SAFENIGHT TECHNOLOGY INC.

September 26, 1995

Re: Response to August 30, 1995 letter

FIGURE 1

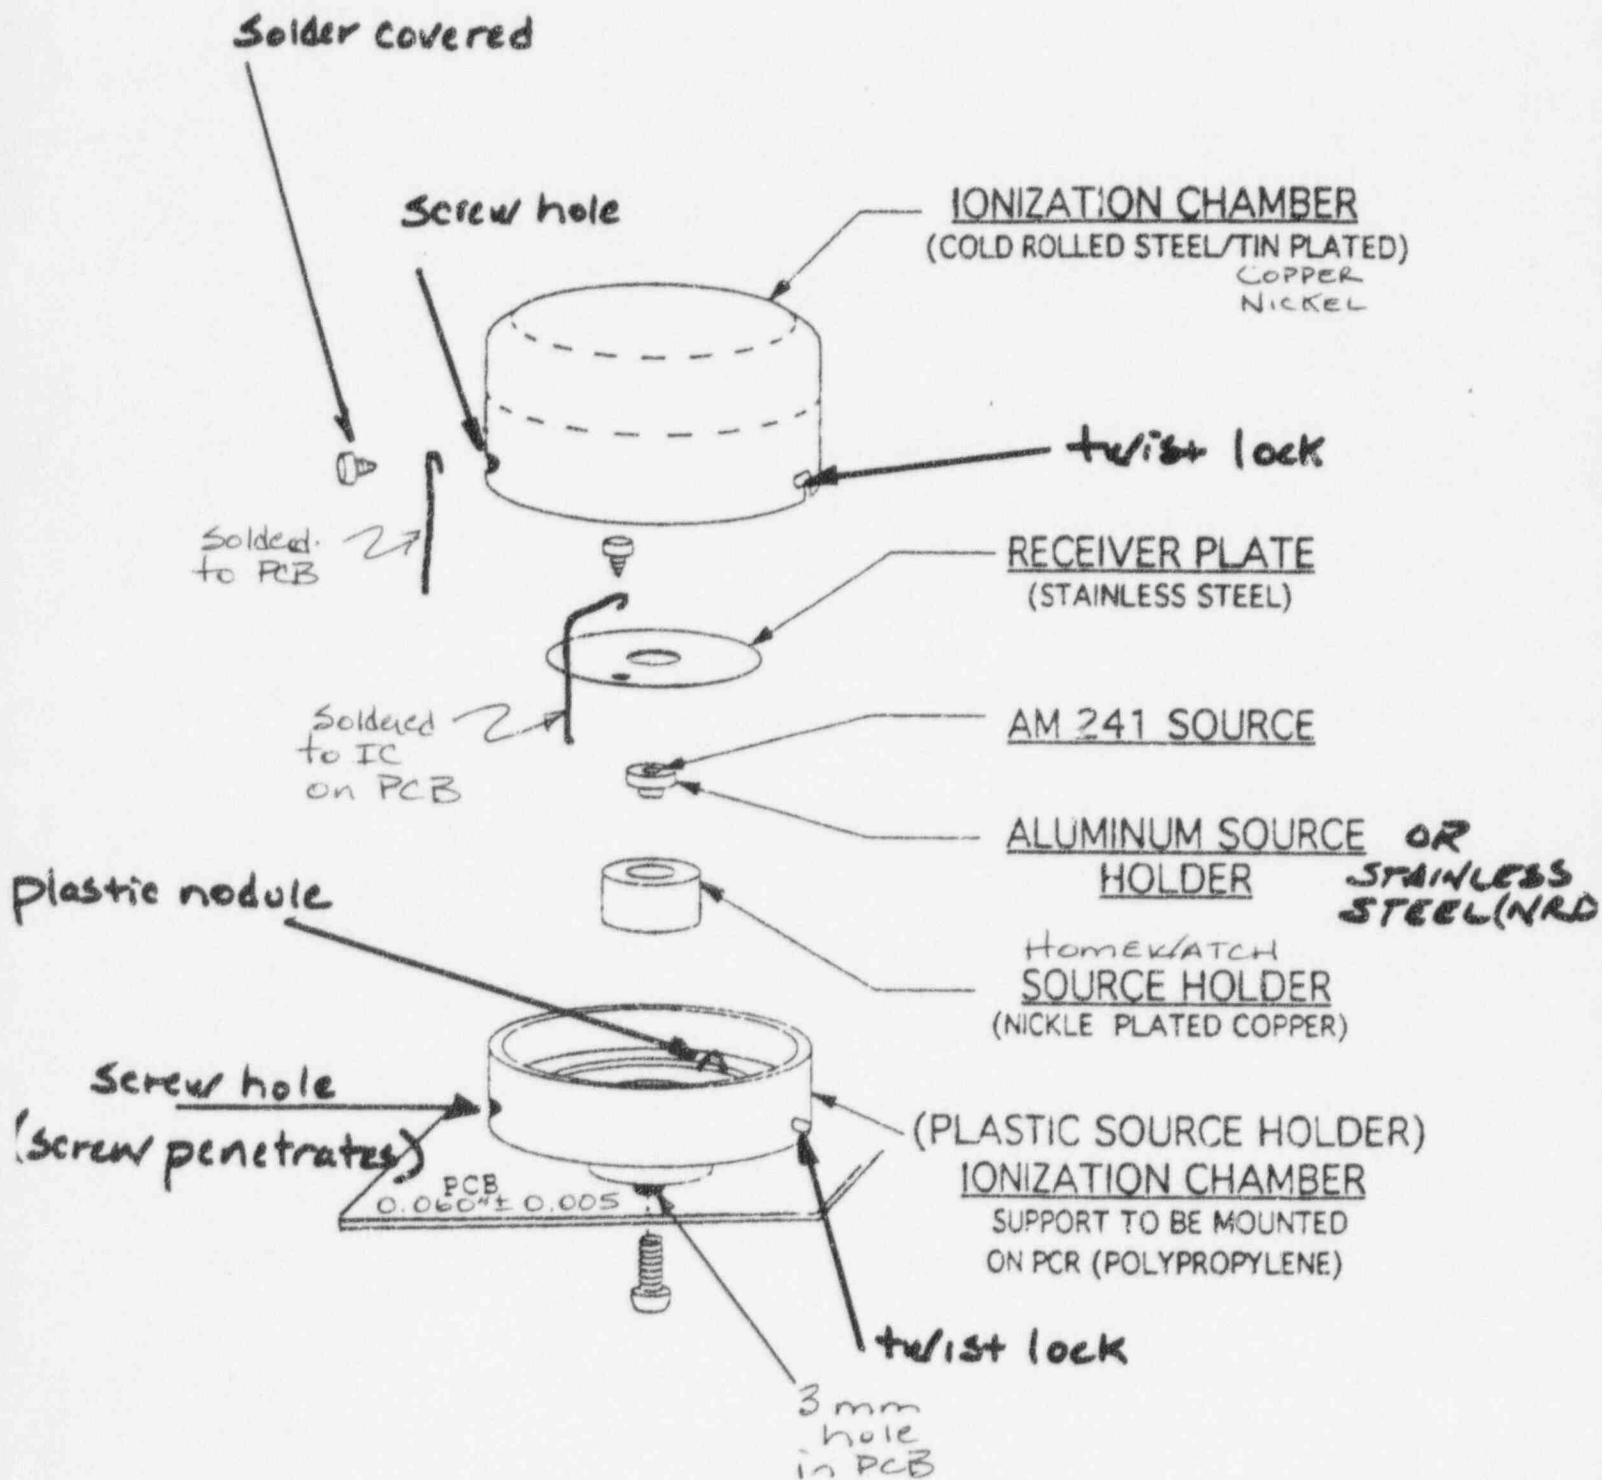
- 1)a) Drawings of button and ion chamber - materials, dimensions and methods of fabrication

The nickel plated copper HomeWatch source holder is fabricated with a female plug in the bottom of it. The aluminum source holder from NRD or Amersham is crimped around the edge with a manually operated crimper into the HomeWatch source holder. Both are then pressed all the way down inside a snug-fitting plastic source holder. The whole process does not contact the sealed source.

There is a gap of approximately 2.2 mm between the top of the source holder and the bottom of the receiver plate. The receiver plate is placed on top of a plastic ledge in

the plastic source support above the source holders and held in place by a screw and a plastic nodule present on the plastic source holder. The screw penetrates all the way down to the plastic holder. The steel tin/copper/nickel-plated cup is then placed over the plastic source holder (again a snug fit) and twist-locked. A screw is applied that penetrates both the steel/tin cup and the plastic source holder. This screw will be covered with solder to prevent tampering. Its presence will prevent any un-twisting action of the cup short of destruction. The chamber will be delivered from our supplier, HomeWatch, at this stage.

FIGURE 5
PCB LAYOUT

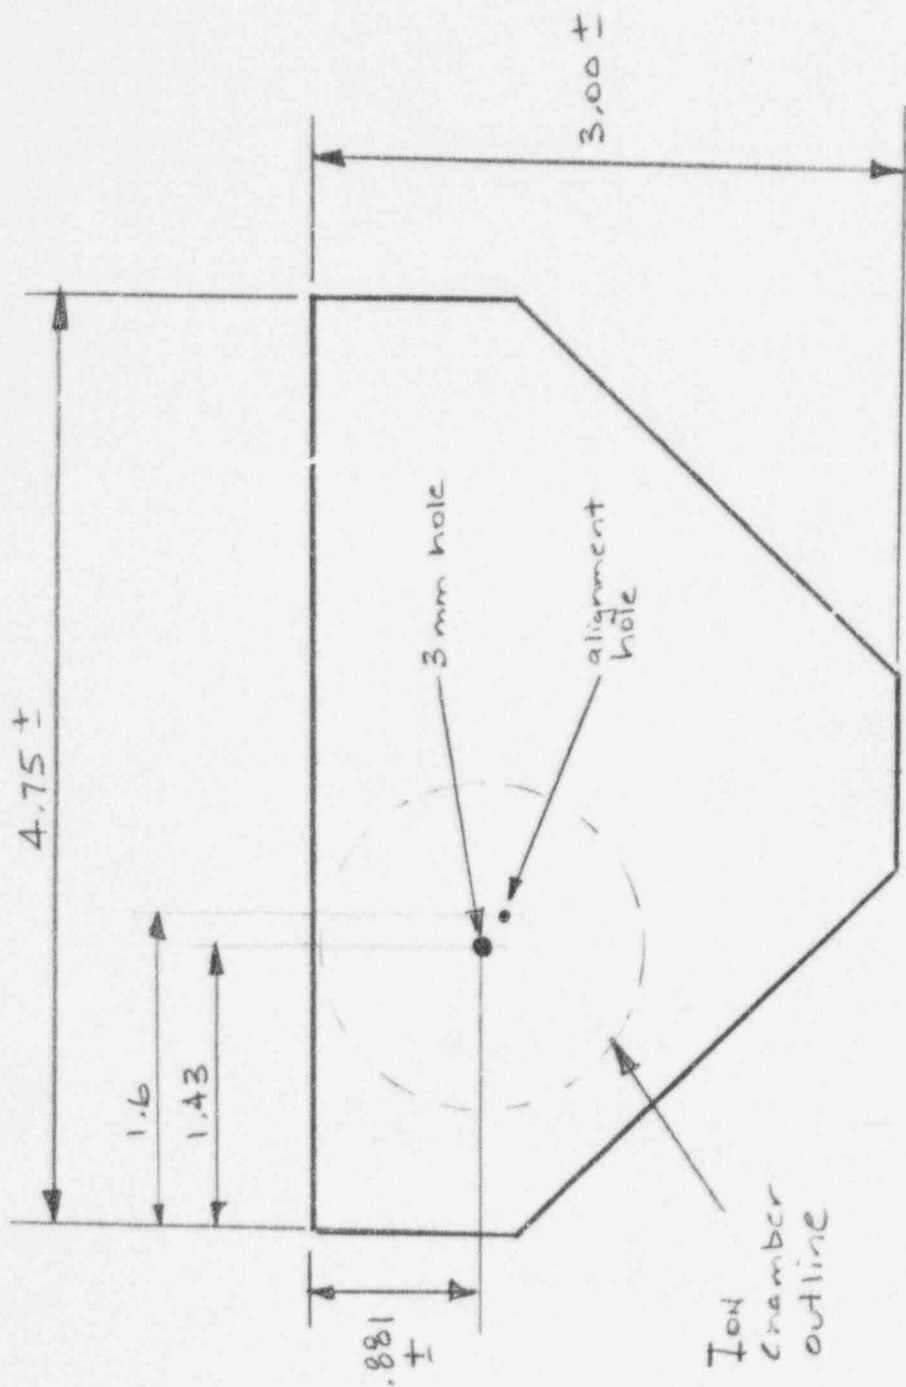
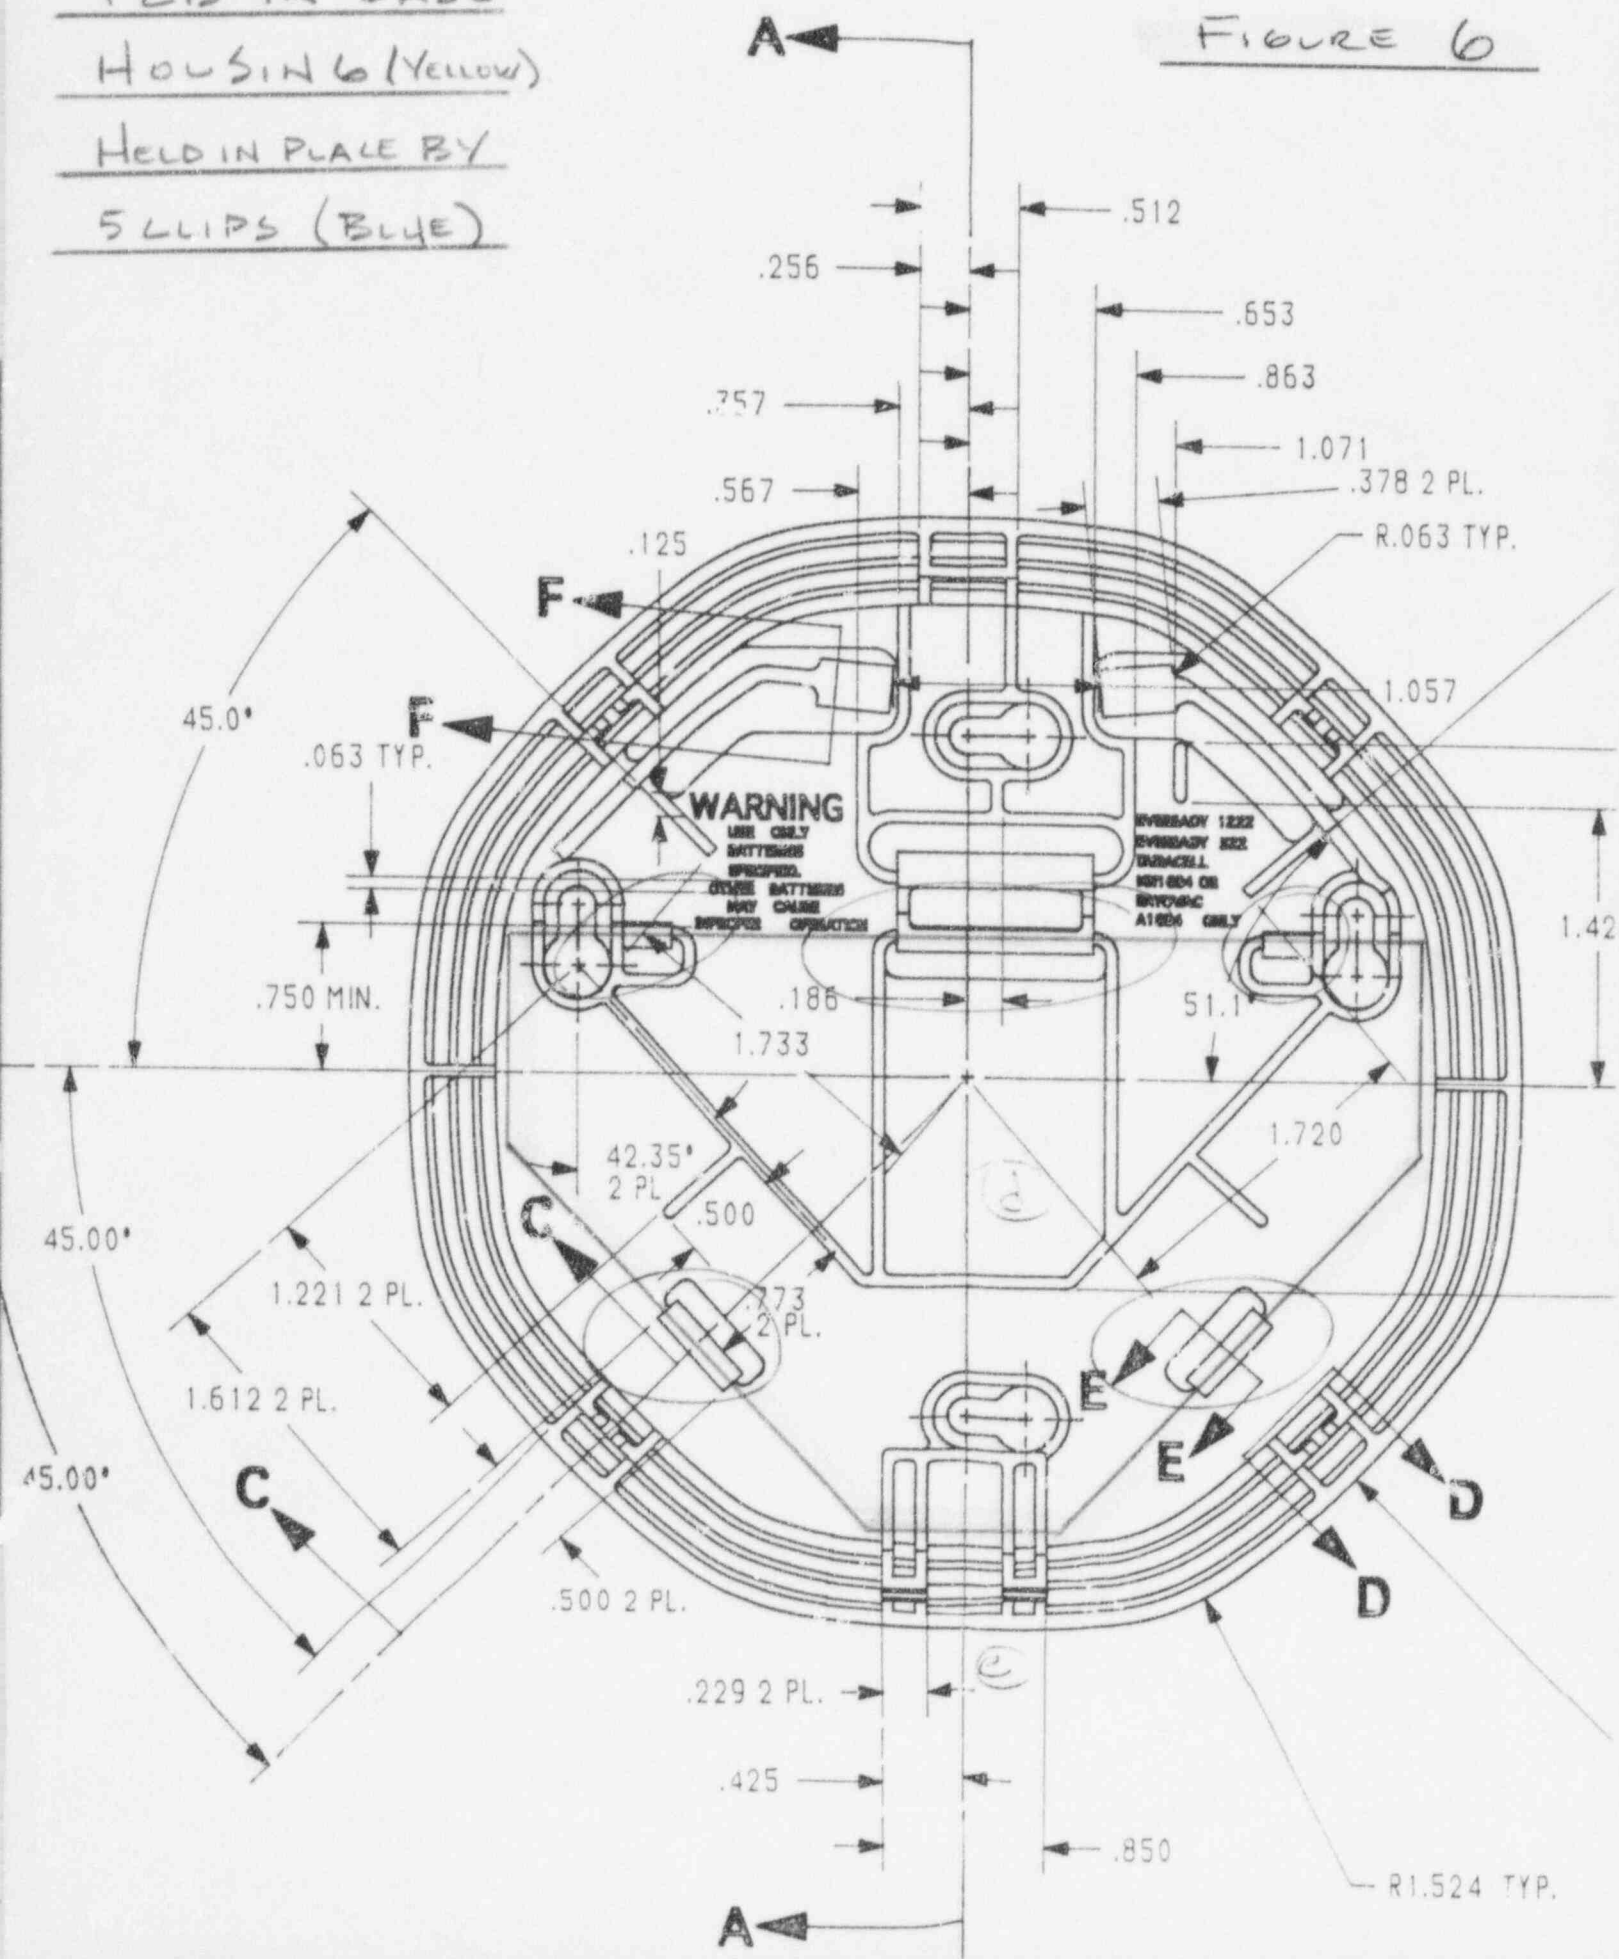
2) a) How is ion chamber connected to circuit board?
See method of fabrication answer to question 1.
Also see Figures 1,2,5.

The chamber is aligned on the PCB using a nodule present at the bottom of the plastic holder and a small hole in the PCB. Then it is screw connected from the other side. The lead wire from the receiver plate is soldered to the smoke detector chip and the other lead wire is soldered to the board. Both will prevent the unscrewing of the chamber from the board short of destruction.

5 LIPS (BLUE)

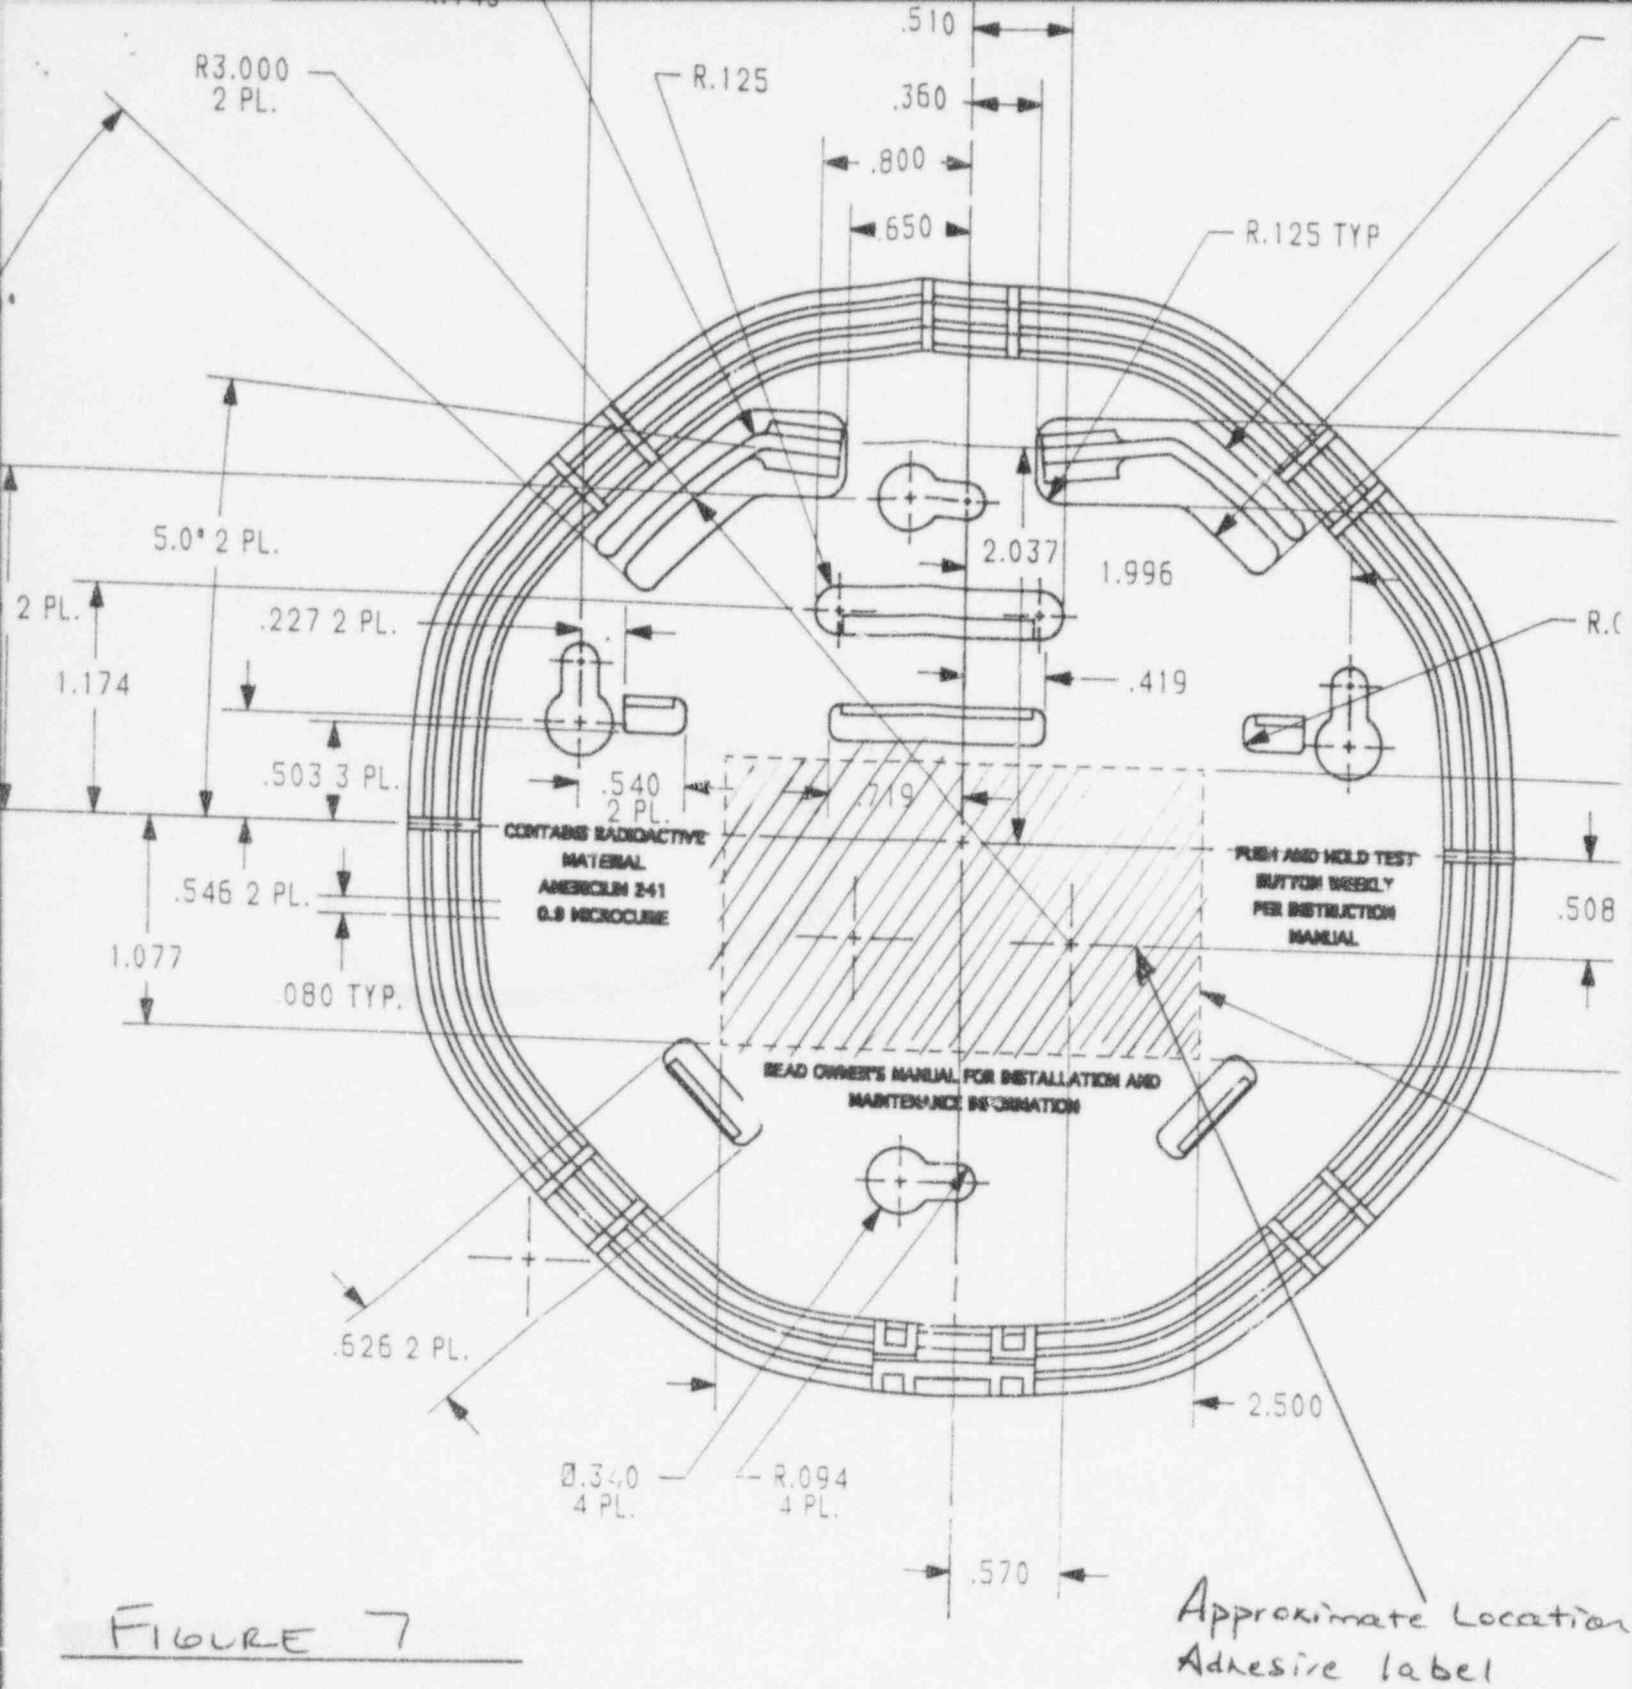
b) How circuit card is secured within smoke detector base? Per drawings with original submission, the PCB is held in place by 5 plastic clips molded into the housing. See Figure 6 which superimposes a circuit card layout onto a housing drawing.
